A303 Amesbury to Berwick Down

**8.37.15 - Responses to the ExA's Written Questions
- Waste and Materials Management
(WM.2)**

Responses to the ExA's Written Questions

- Waste and Materials Management (WM.2)

Schematic Section through A303 and the area east of Parsonage Down

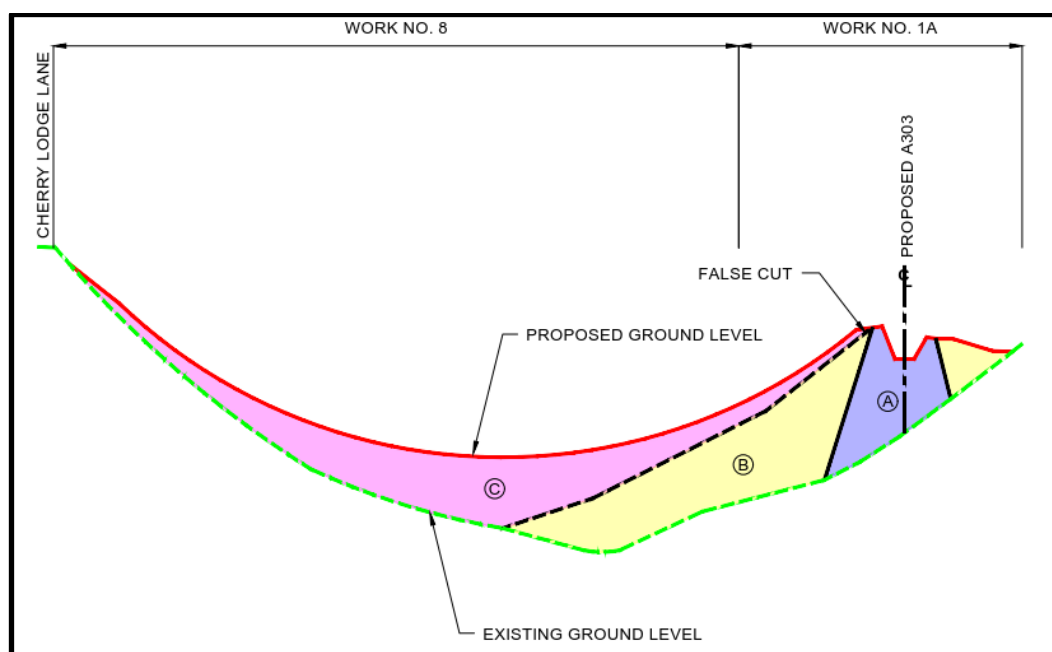
- i. To what extent would the deposition of tunnel arisings form part of Work No.1A being an integral part of the construction of the new A303.
- ii. Should this be specified in Work No.1A rather than solely being specified in Work No. 8?

2. Deposition of tunnel arisings in Work No. 1A is proposed only within the area of landscape fill north of the proposed A303 structural embankment indicated above as zones (B) and (C).
3. Tunnel arisings will not be used for construction of the structural embankment indicated above as zone (A) or for landscape fill south of the structural embankment.

which allows for elements (B) and (C) in the schematic diagram above to form part of Work No.1A. As such, the Applicant does not consider that ‘the deposition of tunnel arisings’ needs to be specified in Work No.1A.

Drawing Title
**COPY OF WORKS PLANS REGULATION 5(2)(j)
SHEETS 3 AND 12 COMBINED**

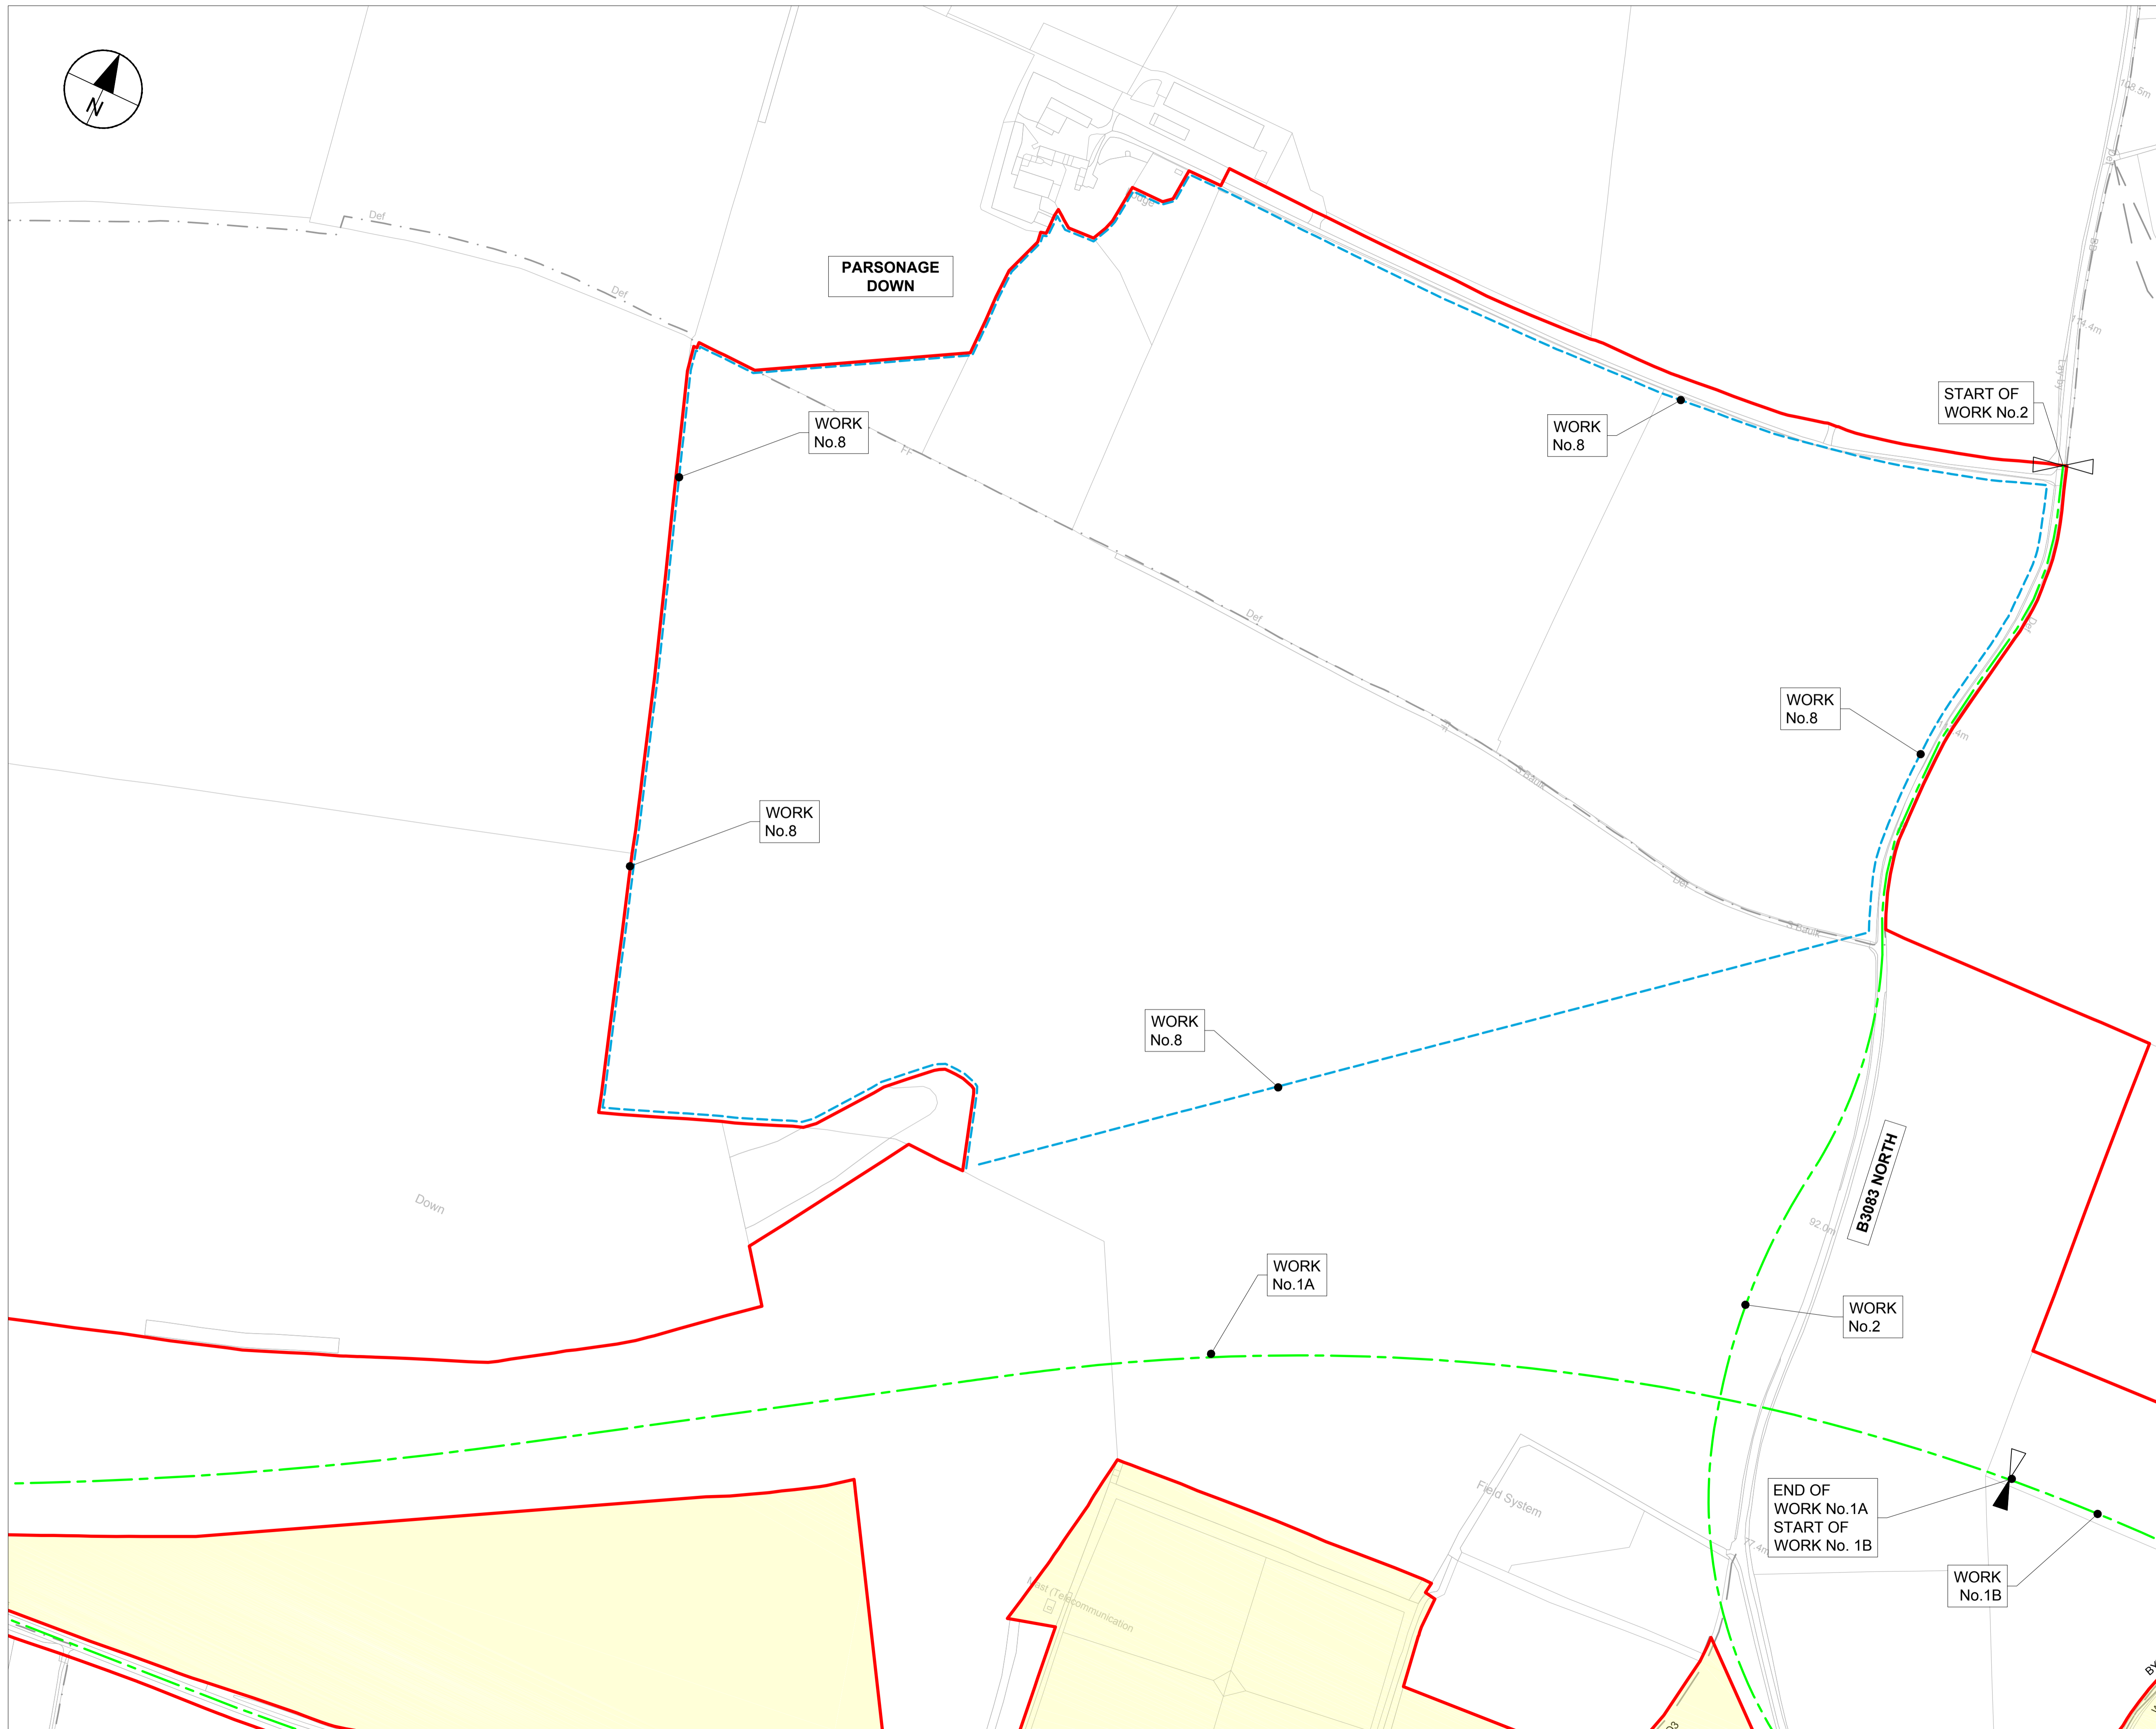
Please provide an additional sheet for the Work Plans combining sheet 3 and sheet 12.

1. Highways England has adopted a standard tile pattern which has been adopted for the sheets in the majority of the sets of DCO plans and for a number of figures in the Environmental Statement. This tile pattern has been chosen to provide adequate plan coverage while minimising the duplication of information on different sheets. Its consistent application across the documentation also provides clarity and facilitates 'read-across' between the different application documents. The Applicant is therefore reluctant to create an additional sheet for one particular set of drawings (i.e. the Works Plans [APP-008]). However, for the purposes of responding to the Examining Authority's question, a figure has been produced and is appended to this response, to show copy extracts from the Works Plans sheets 3 and 12, covering the full extent of Work No.8 and the adjacent length of Work No.1A.

2. For the avoidance of doubt, whilst the appended figure is based on, and is a copy of the information shown on sheets 3 and 12 of the Works Plans, in the event that there is any discrepancy of whatever nature between the figure itself and the Works Plans on which the figure is based, then the Works Plans [APP-008], which are required to be certified by the Secretary of State as true copies pursuant to article 56 and Schedule 12 to the DCO, shall always prevail.
